# HS2 Phase 2b '2019 Design Refinement' Consultation Response of Leicestershire County Council September 2019

## 4. Leicestershire County Council consultation response: Realignment of the route between Ashby-de-la-Zouch and Diseworth, Leicestershire

Figure 1 suggested location for pedestrian refuge between farm access points

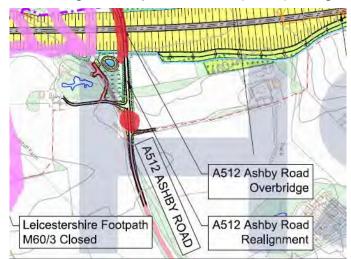
- 4.15. To consider a pedestrian refuge at the point marked (in red) on figure 1:

Figure 3: Lount Meadows SSSI

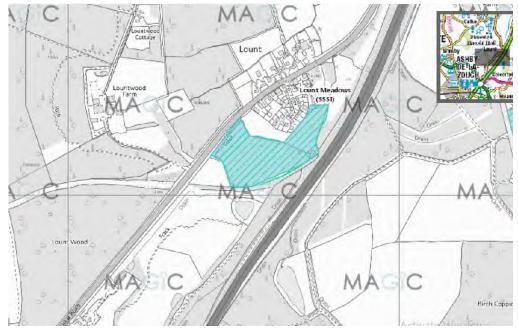
4.55. The location of the Lount Meadows SSSI is shown in light blue on the map below (Figure 3). LCC has concerns that the close proximity of the line of route has the potential to cause impacts from dust, noise and possibly from disruptions to the water table. The County Council therefore requests that a full impact assessment is carried out and results shared prior to the deposition of the hybrid Bill.
